| Project        | <b>IEEE 802.16 Broadband Wireless Access Working Group</b> < <a href="http://ieee802.org/16">http://ieee802.org/16</a> >   |
| Title          | <b>Details of SDD Section 11.9.2.2 Uplink HARQ Feedback Channel</b>  |
| Re:            | SDD Session 56 Cleanup, Call for PHY Details   |
| Abstract       | This is revised version of Section 11.6 of IEEE 802.16m-08/003r4. This document provides further physical layer details.   |

Figure 1. UL HARQ feedback channel pilot and data Tone allocations

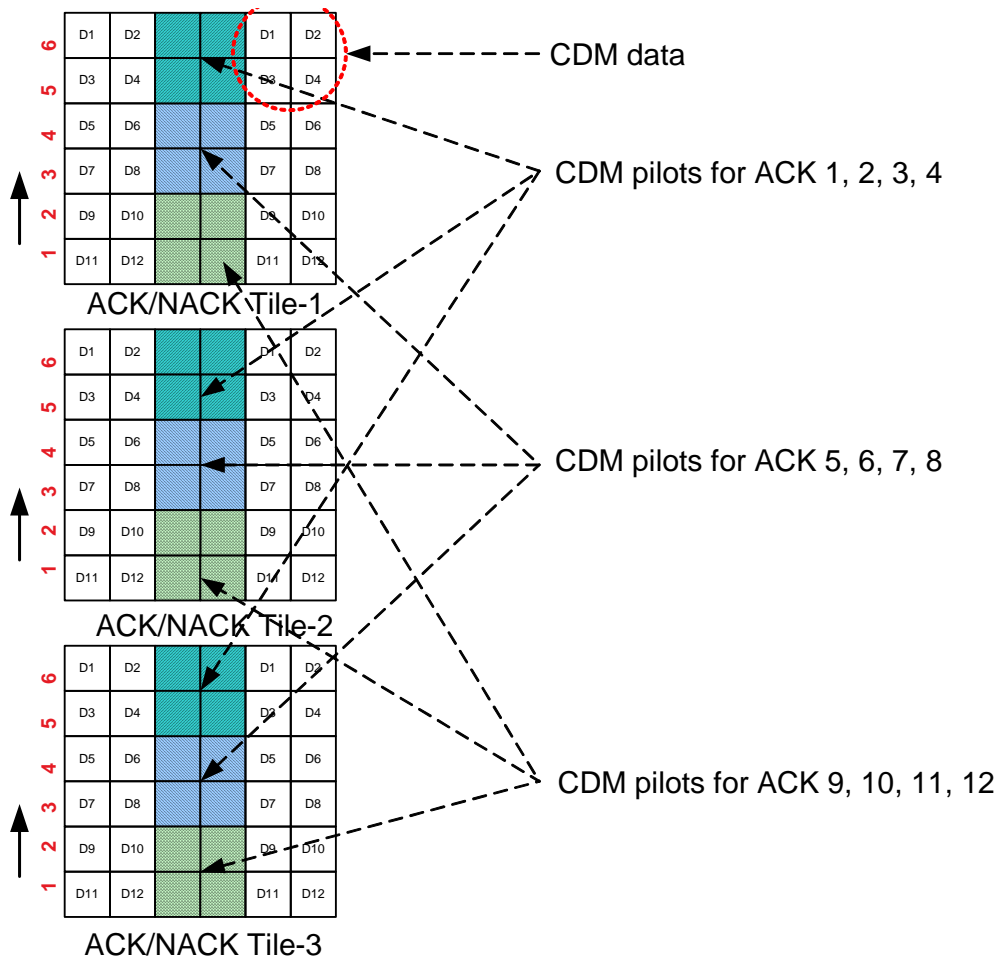
17 Twelve UL HARQ feedback channels are multiplexed together using a mixture of FDM/TDM/CDM in three  
18 UL DRU tiles. For each group of four tones that are adjacent in time and frequency, pilot and data symbols  
19 from four HARQ feedback channels are CDMed together in order to take full advantage of the MS transmit  
20 power. Further, since these four tones are adjacent in time and frequency, orthogonal codes can be used to  
21 separate the four HARQ feedback channels. Finally, multiple groups of four tones are allocated in each tile  
22 with FDM/TDM. The pilot and data tone allocations are shown in Figure 1.  
23  
24  
25  
26  
27  
28

Figure 2. UL HARQ feedback tile allocations

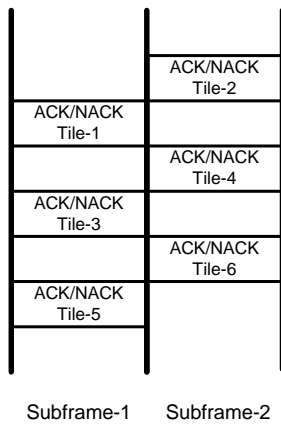
In order to improve the coverage of HARQ feedback channel for cell edge MSs, the UL HARQ feedback tiles are allocated in time dimension first as shown in Figure 2. Further, subframe based frequency hopping of the tiles can be applied to improve the frequency diversity.
